Description of the Amendments to the Drawings:

REMARKSRegarding the Allowable Subject Matter:

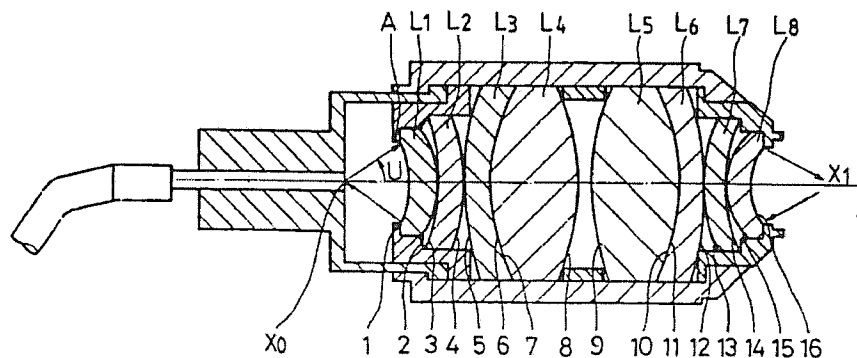
The *Chao et al.* reference, on the other hand, does not disclose at least two focusing optical elements, wherein at least two optical axes of the focusing optical elements are not collinear. As can be seen in FIG. 1, reproduced below, the optical axes of lenses, $L_1 - L_8$, are all collinear.

As discussed above, the *Chao et al.* reference does not disclose at least two focusing optical elements, wherein at least two optical axes of the focusing optical elements are not collinear. Instead, the optical axes of lenses, L₁ – L₈, are all collinear. Applicants respectfully submit that a skilled artisan had no apparent reason to arrive at the present invention, which requires at least two optical axes of the focusing optical elements not to be collinear. The *Chao et al.* reference provides no hint that such a modification would be desirable.

lenses. L4 is the same size and shape as L5. L3 is the same size and shape as L6. L2 is the same size and shape as L7. L1 is the same size and shape as L8. This symmetry is also clearly illustrated in FIG. 1.
